CHRIST CHURCH BEXLEY

DEVELOPMENT APPLICATION DESIGN REPORT

COUNCIL RFI RESPONSES

08.03.2023

Option 1: Increasing ramp grade to basement car park + maintain building height

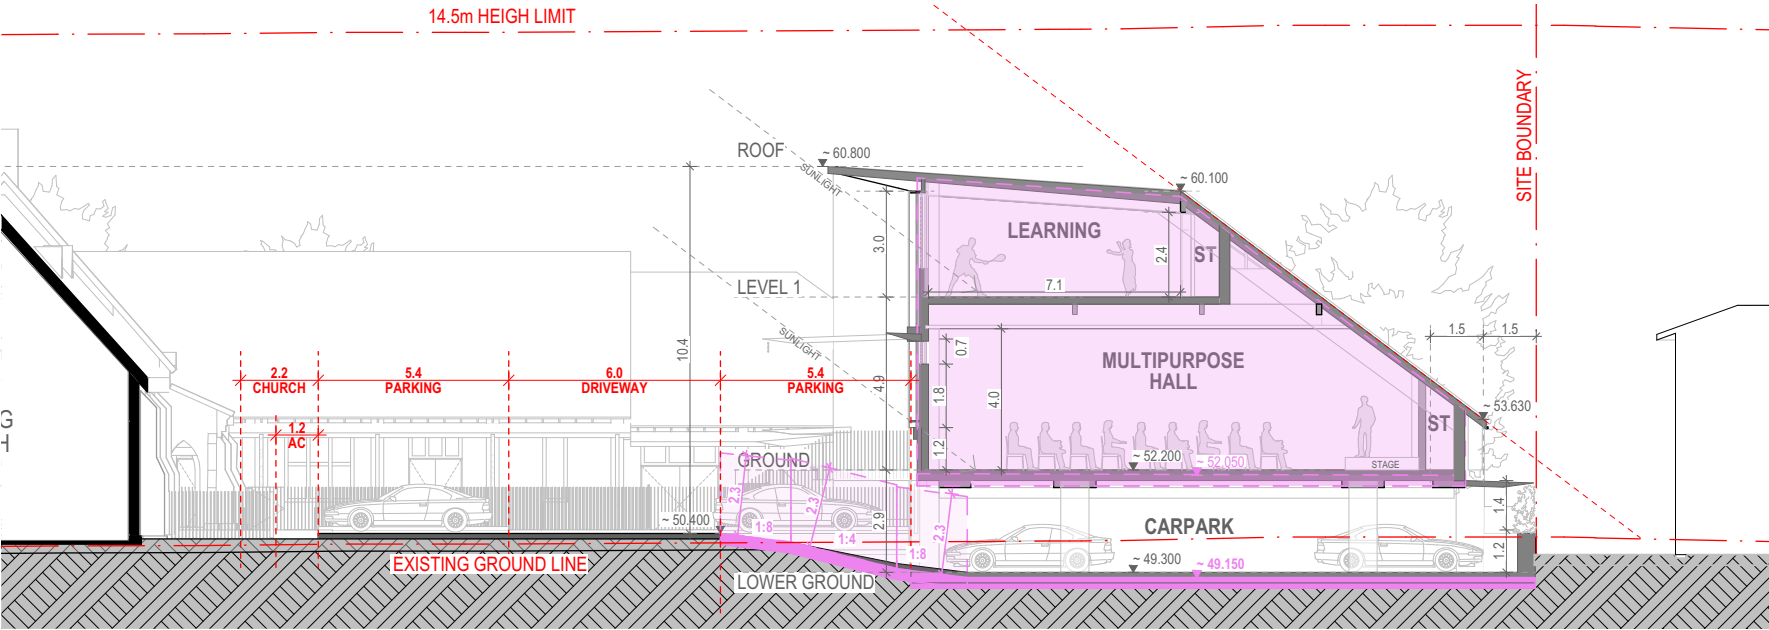
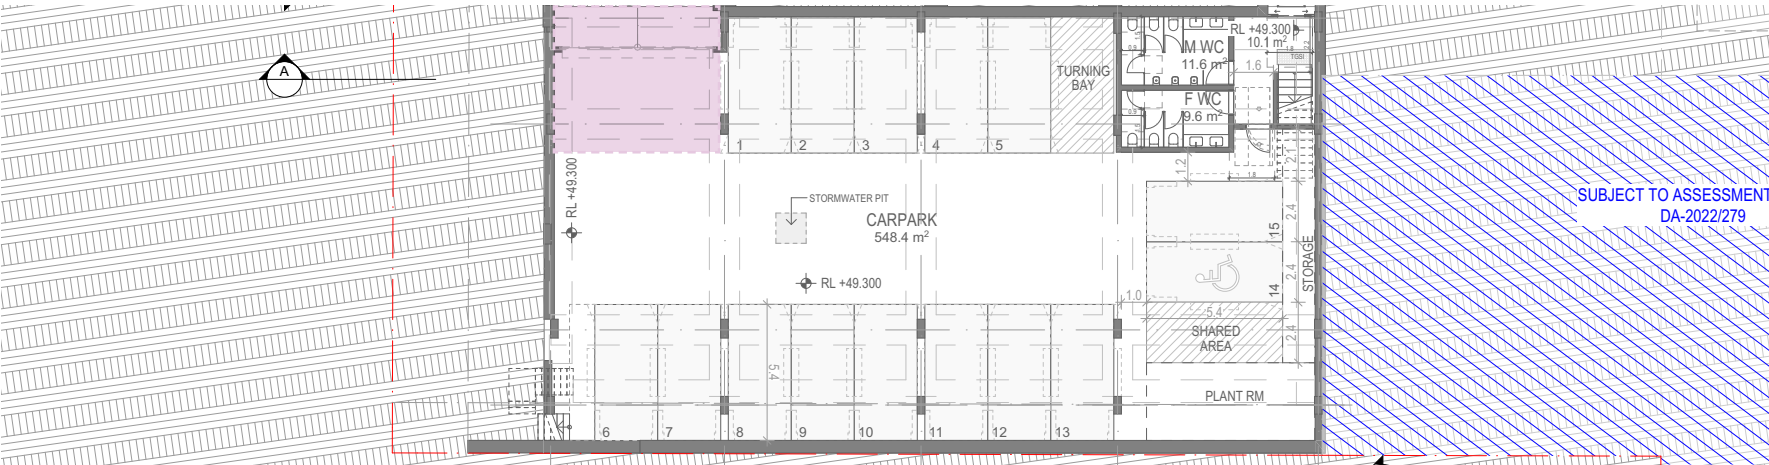
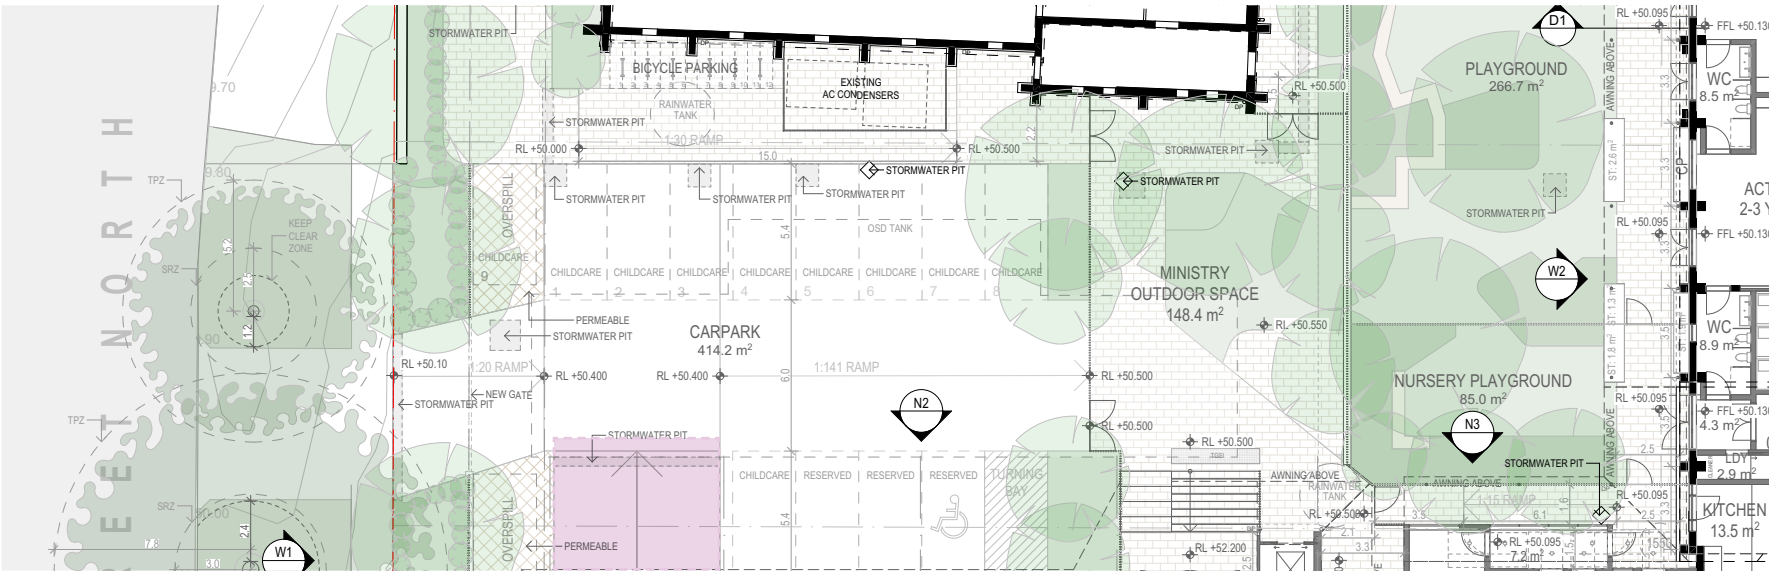
Council request:

Council’s Urban Designer recommended that the internal ramp to the basement car park be increased to a 1:4 ramp with 1:8 transitions. This was an attempt to lower the floor level of the car park to RL. 48.150.

Ramping grade:

This option was explored by the Applicant, however based on transport planning advice received by Josh Milton of JMT Consulting on 25 October 2022, it was confirmed that such an arrangement would be inconsistent with Australian Standard AS2890.1-2004 Parking facilities - Off-street car parking. Only driveways serving serving Class 1 (residential/ commercial) car parks are permitted to have a ramp gradient of 1:4. The maximum gradient for public areas is 1:5 ramp gradient with 1:8 transitions.

Council response:

This specific matter was raised in a meeting between the Applicant and Ben Latta and Adam Iskander of Bayside Council on 26 October 2022.

The Applicant was advised to maintain the 1:5 ramp grade for safety reasons (i.e. to take a ‘standard and conservative approach’) and acknowledging that the mutlipurpose hall would be used for ministry and community activities.

Option 2A: Increasing ramp grade to basement car park + reduce building height

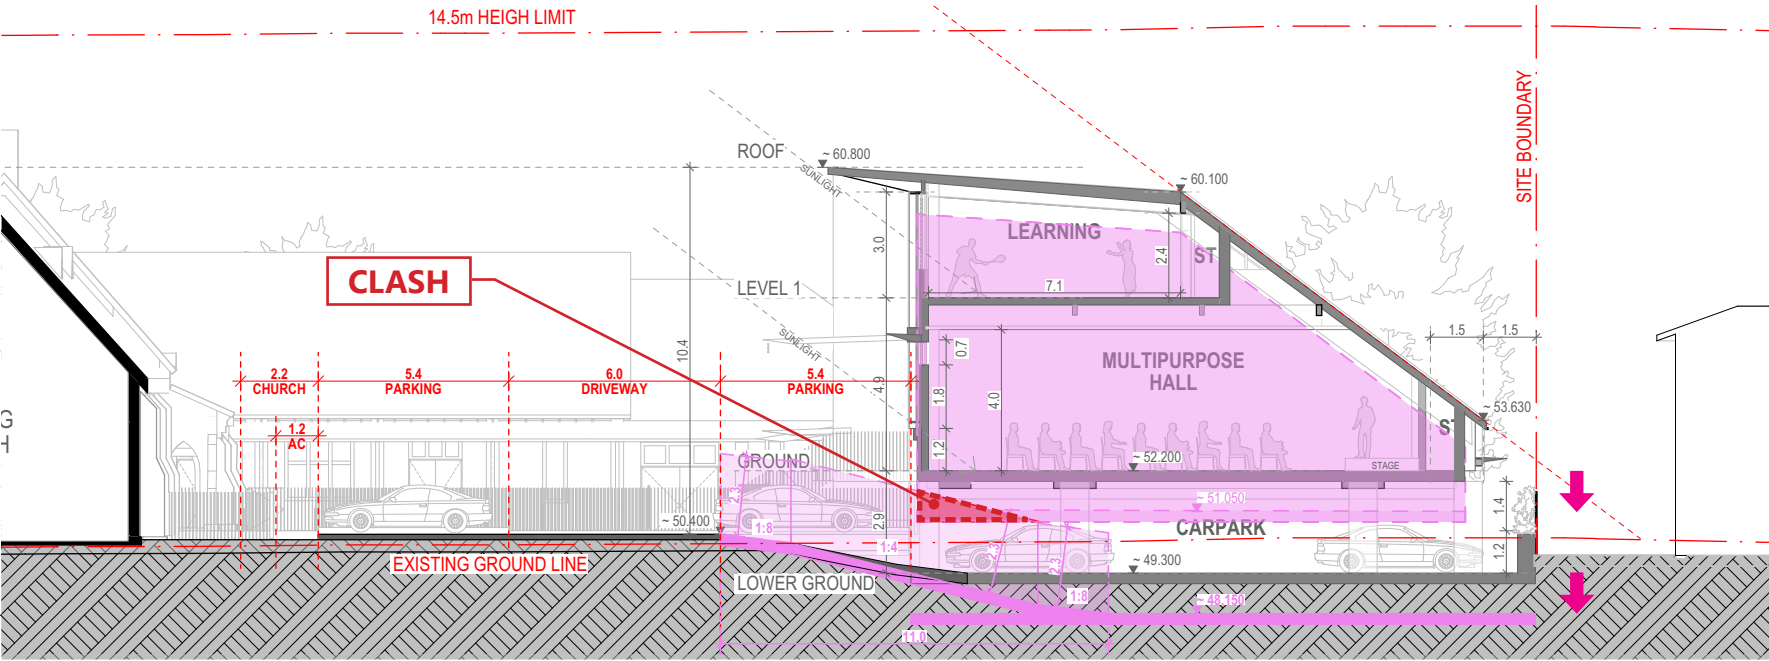
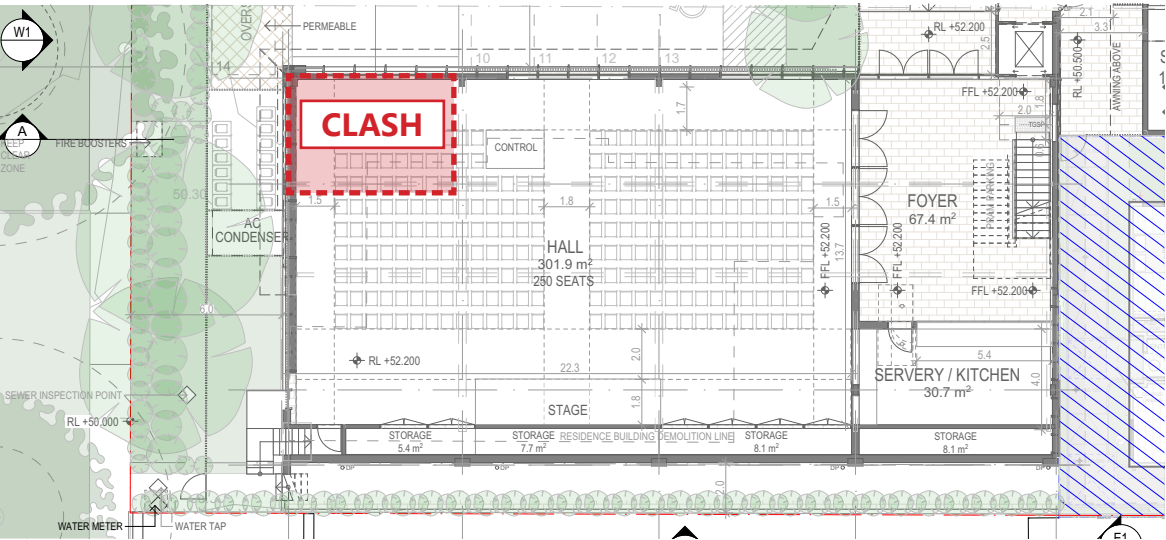
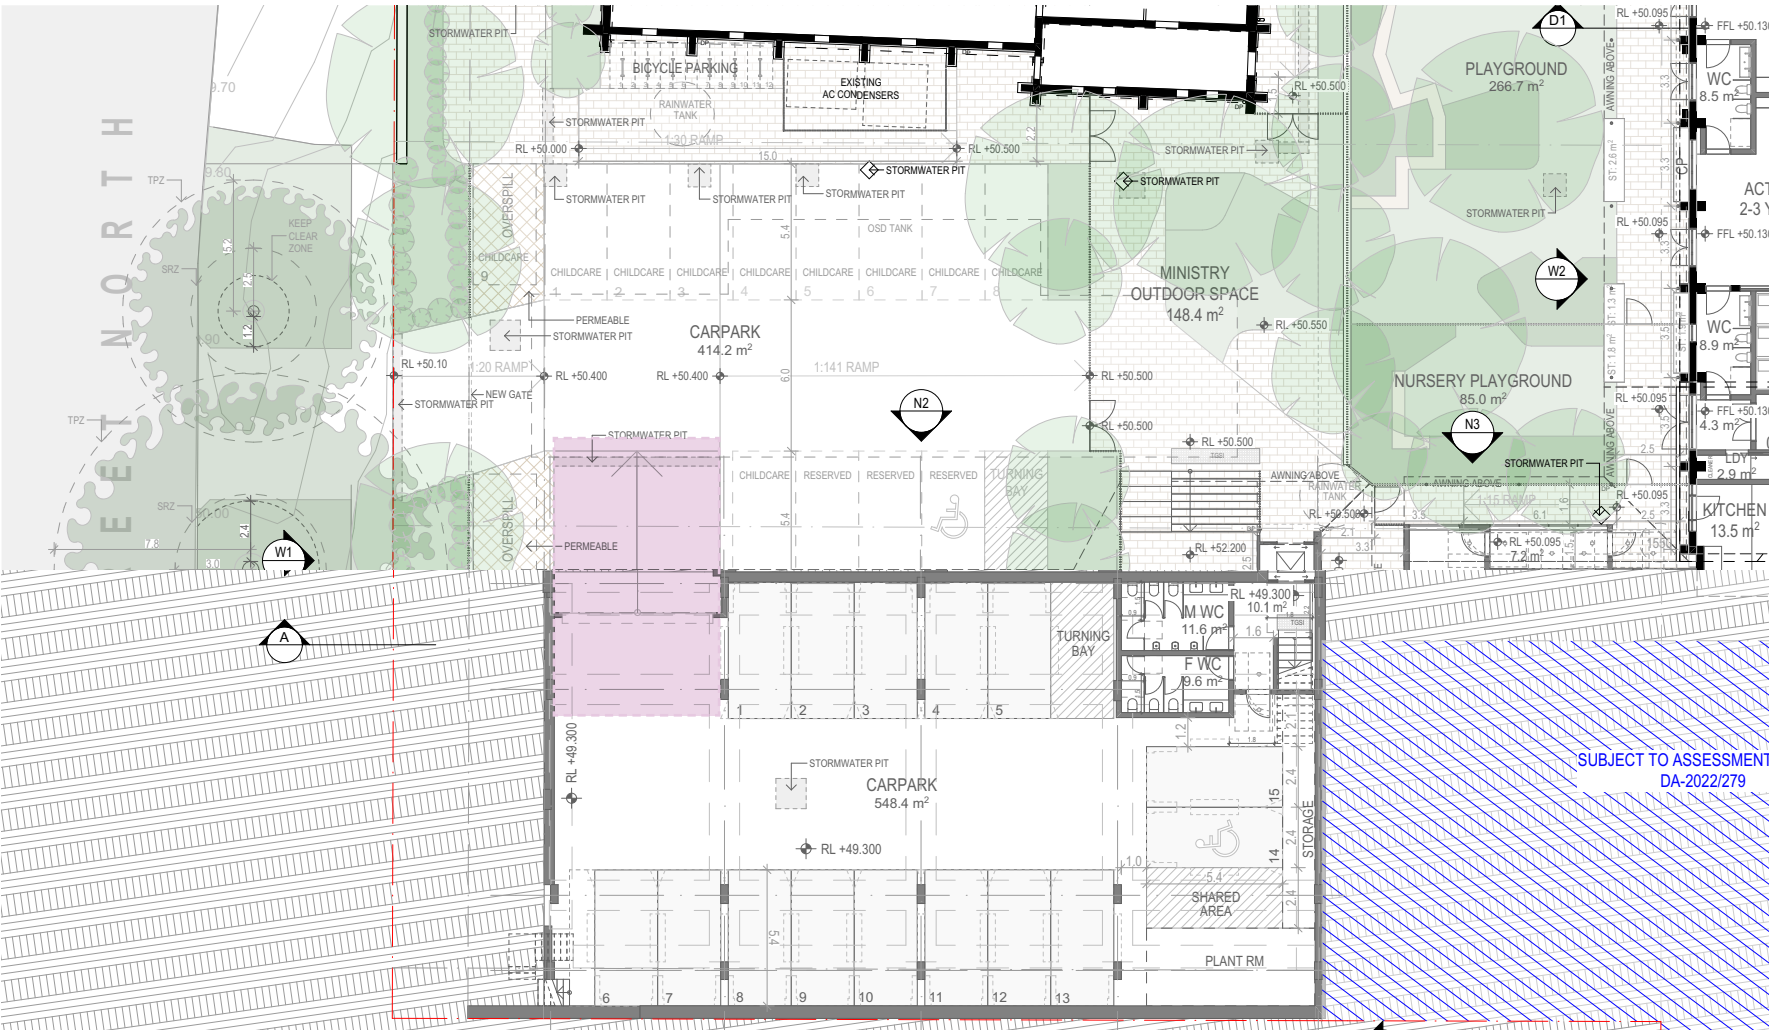
Council request:

Council’s Urban Designer recommended that the internal ramp to the basement car park be increased to a 1:4 ramp with 1:8 transitions. This was an attempt to lower the floor level of the car park to RL. 48.150.

In addition, a request was made to lower the floor level of the Ground Floor to RL 51.

Ramping grade:

This option was explored by the Applicant, however based on transport planning advice received by Josh Milton of JMT Consulting on 25 October 2022, it was confirmed that such an arrangement would be inconsistent with Australian Standard AS2890.1-2004 Parking facilities - Off-street car parking. Only driveways serving serving Class 1 (residential/ commercial) car parks are permitted to have a ramp gradient of 1:4. The maximum gradient for public areas is 1:5 ramp gradient with 1:8 transitions.

Building height reduction:

The request to see the overall building height lowered and the floor level of the Ground Floor reduced to RL 51, results in a clash with the 2.3m headroom clearance necessary for a vehicle to enter the basement.

Furthermore, the clash would result in the ground floor multipurpose ministry hall be severely compromised with the loss of at least 20 seats or 8% of the overall capacity of the hall.

Council response:

This specific matter was raised in a meeting between the Applicant and Ben Latta and Adam Iskander of Bayside Council on 26 October 2022.

The Applicant was advised to maintain the 1:5 ramp grade for safety reasons (i.e. to take a ‘standard and conservative approach’) and acknowledging that the mutlipurpose hall would be used for ministry and community activities.

The clash issue was acknowledged by Council officers as an undesirable outcome. Option 2B was then presented as an alternative to avoid the headroom clash.

Option 2B: Increasing ramp grade and length to basement car park + reduce building height (to avoid head room clearance issues)

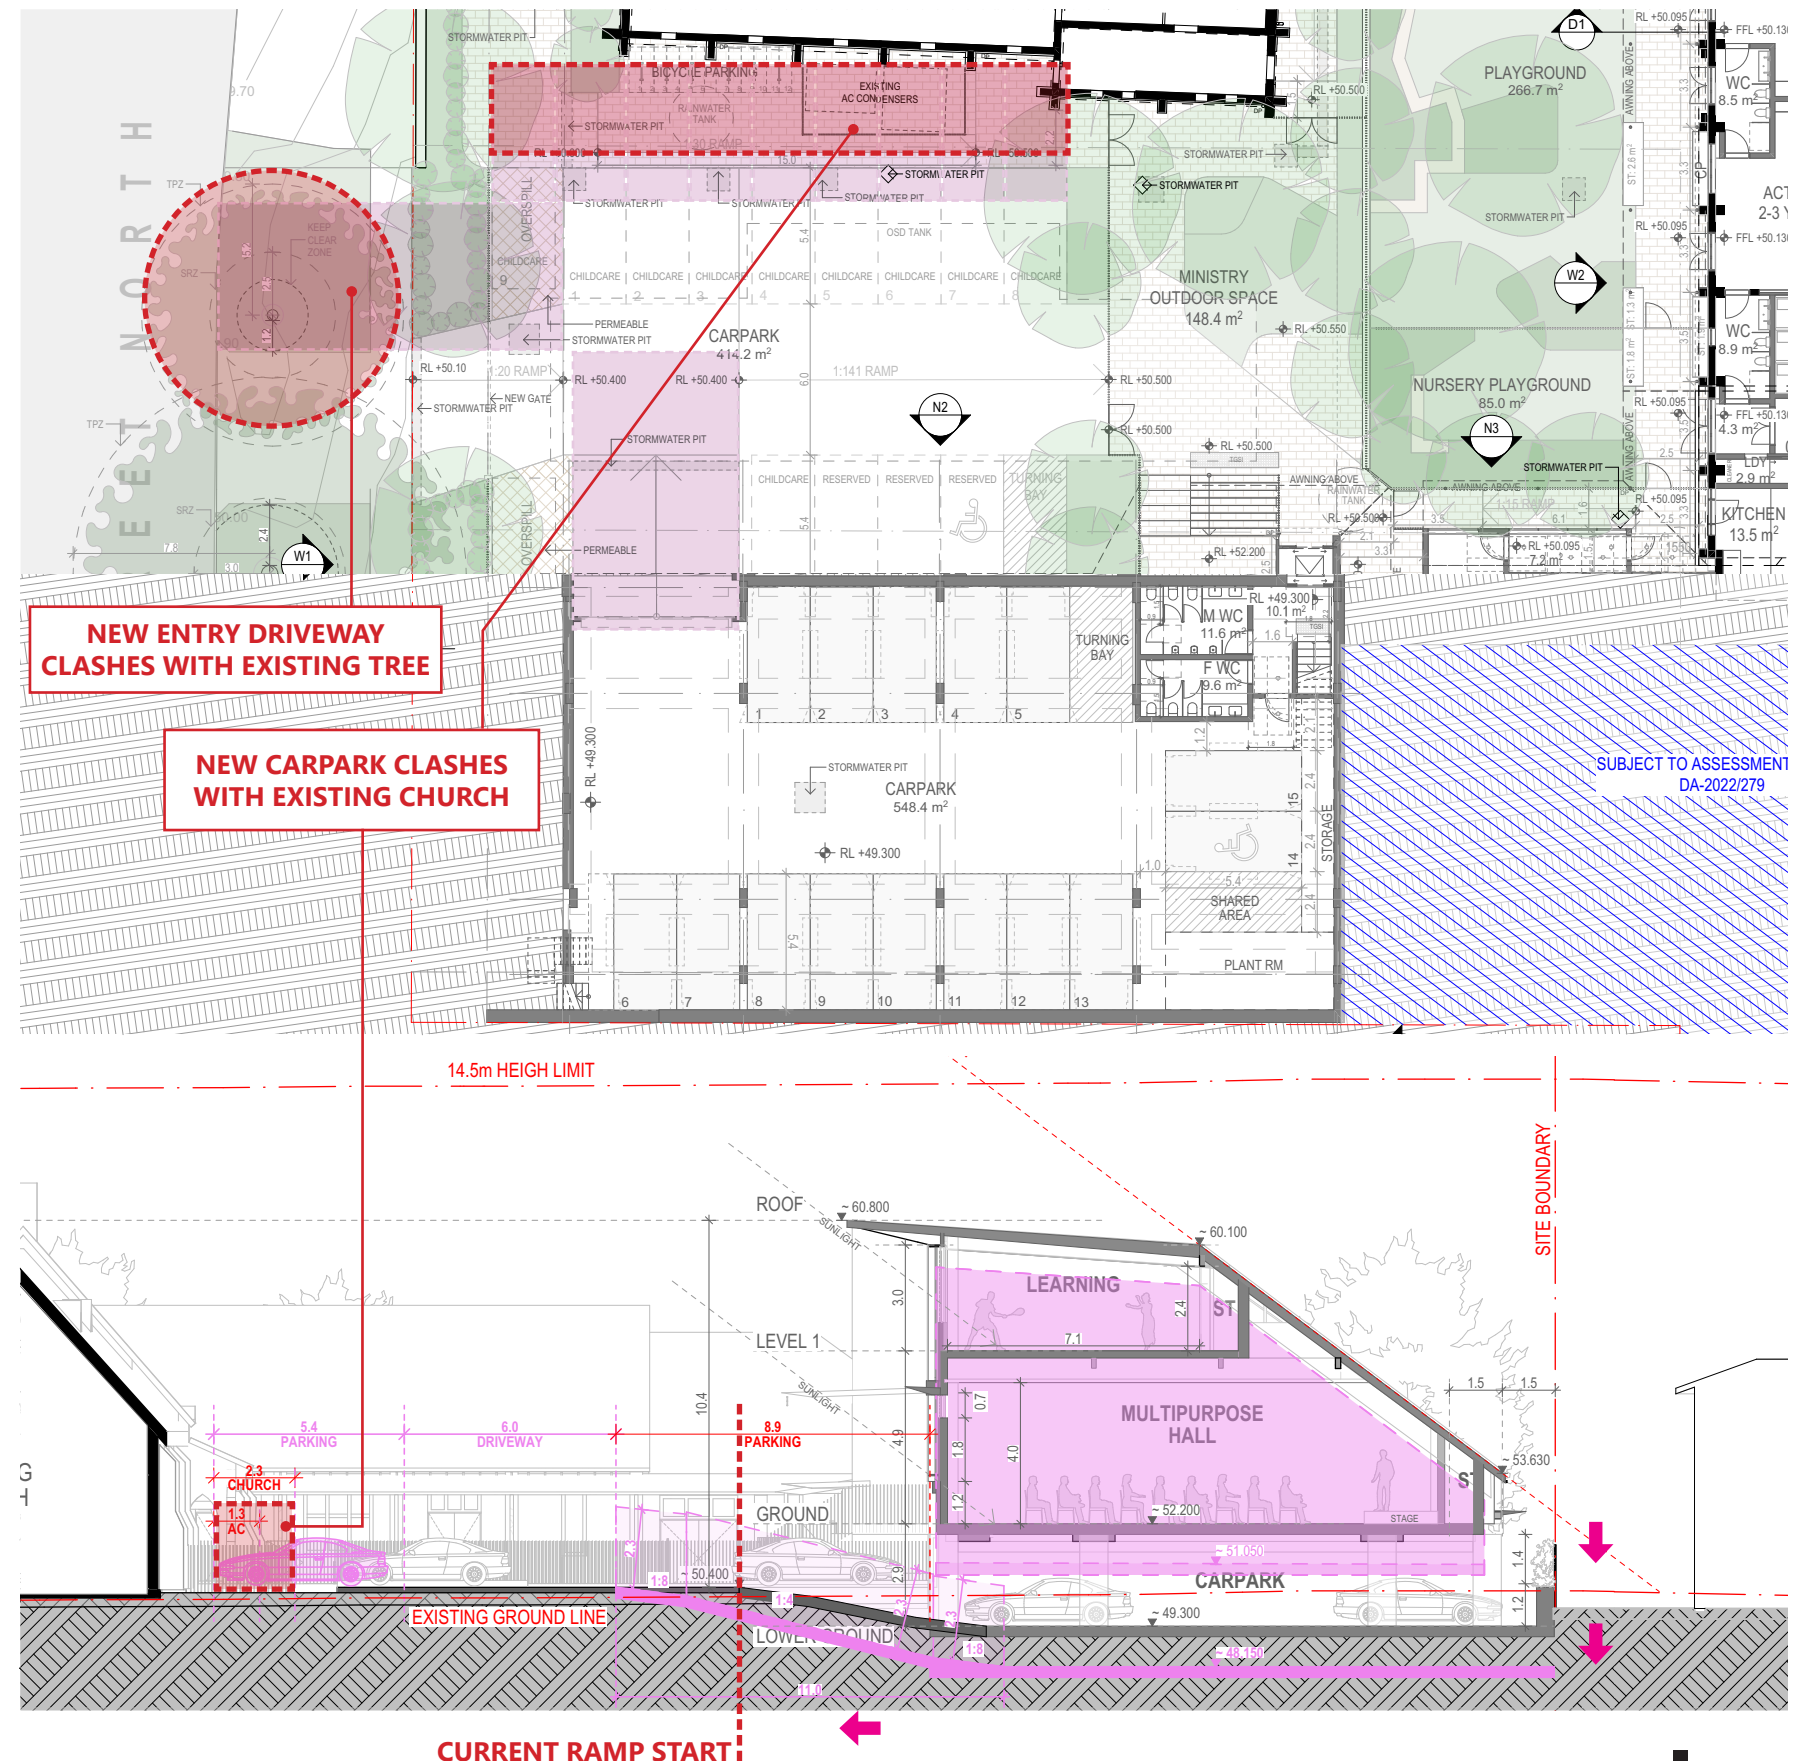
Council request:

Council's Urban Designer recommended that the internal ramp to the basement car park be increased to a 1:4 ramp with 1:8 transitions. This was an attempt to lower the floor level of the car park to RL. 48.150.

In addition, a request was made to lower the floor level of the Ground Floor to RL 51.

Increase in ramp length:

In order to avoid the headroom clearance issue, the ramp length would need to be extended into the at-grade parking area. As a result, the driveway entry from Dunmore Street N would need to be relocated northwards. This would result in the following impacts:

1. The removal of a heritage-listed Queensland Brush Box tree within the road reserve for the purposes of a new driveway crossover.
2. The removal of nine (9) at-grade car parking spaces as shifting these spaces directly adjoining the heritage church would likely result in an unacceptable planning outcome.

Council response:

This specific matter was raised in a meeting between the Applicant and Ben Latta and Adam Iskander of Bayside Council on 26 October 2022.

The Applicant was advised to maintain the 1:5 ramp grade for safety reasons (i.e. to take a 'standard and conservative approach') and acknowledging that the multipurpose hall would be used for ministry and community activities.

The removal of the existing heritage-listed street tree was recognised as an unfavorable planning outcome. The conflict with the at-grade parking was also acknowledged.
